Trees and your proposed building plans at Lane End.

Roland submitted the application to Barnsley Council (the local planning authority) who have requested information on the affected trees. I am familiar with the *British Standard 5837 2012 Trees in relation to design demolition and construction – Recommendations*, which is the usual guidance for the appraisal of trees on development sites, and which is mentioned in Barnsley's supplementary planning guidance document; "trees and hedgerows." I am also familiar with the National Planning Policy Framework (NPPF), which is the guidance that instructs Councils on how to treat planning applications. Paragraph 44 of the NPPF states that information requirements to accompany a planning application "should be kept to the minimum needed to make decisions."

SP1

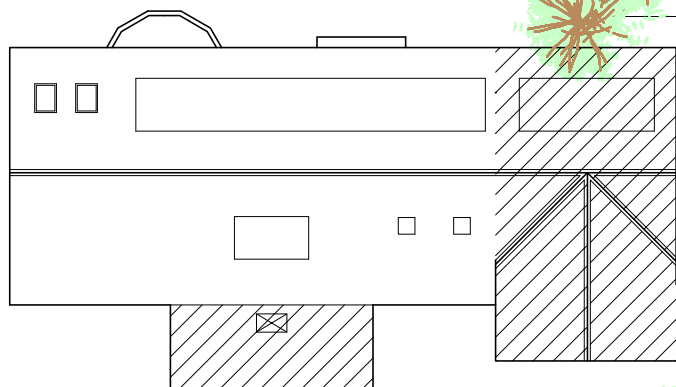
Photograph 4 shows T2. This is a Drummond's Maple. The cultivar arose in Europe about a century ago. The drawing identifies it as Japanese but this is incorrect.

It is 240 mm diameter and 6 metres tall. The property's front garden contains a large number of Japanese Maples but Drummond's Maple is a cultivar of Norway Maple. This cultivar has a proclivity to lose the variegated foliage and revert to being no different to a Norway Maple. Enthusiastic gardeners like you prune out the reverted branches to maintain the tree's variegated foliage.
